**Interim Verification Report
Investigation of
Peoples Gas Pipeline Safety Program**

Illinois Commerce Commission

October 2, 2009

Reduce the year-end leak backlog.

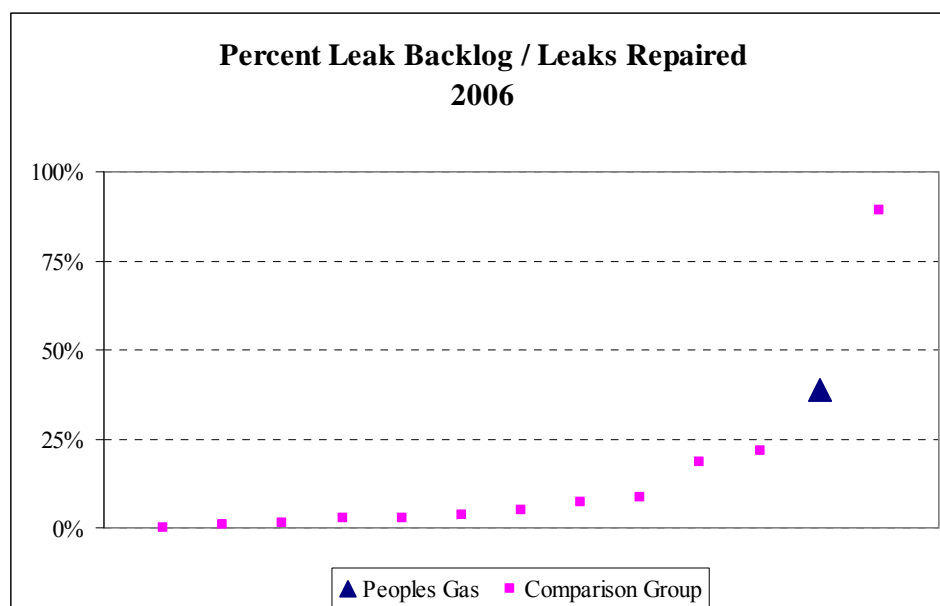
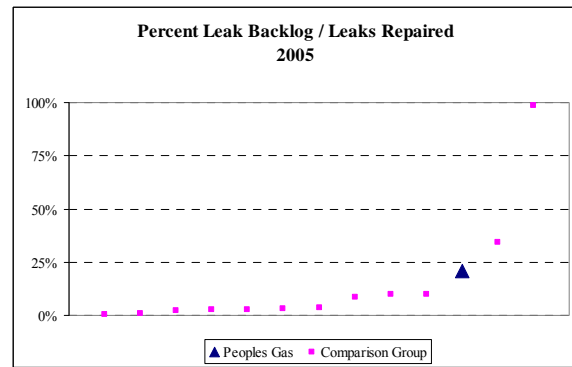
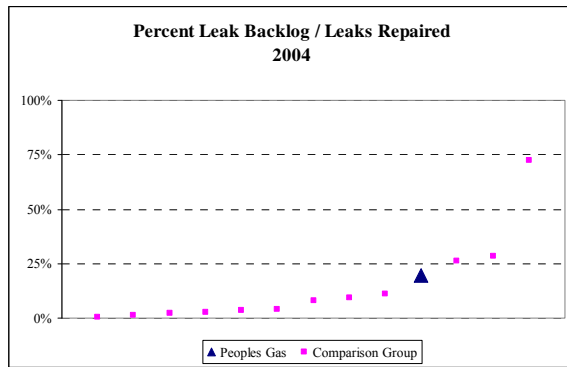
Peoples Gas needs to repair more leaks and reduce the level of backlogs at year-end. In both relative terms, compared to its peers, and absolute numbers of leaks outstanding, Peoples Gas' leak backlog is too high. Peoples Gas should reduce the backlog so that the percentage of the leaks in backlog at year-end is less than 10 percent of the number of leaks repaired during the year. Peoples Gas should develop and implement a written plan for meeting this recommendation. The plan should include specific goals for reducing leak backlogs and repairing more leaks, including target levels for leak backlogs at year-end for the current and following two years.

Peoples Gas has had a comparatively large leak backlog at year-end, a time of year when frost cover presents the highest risk for hazardous gas leak migration. Peoples Gas carried over 500 leaks in need of repair at year-end 2005. This level of backlog is high in relation to the number of leaks repaired.
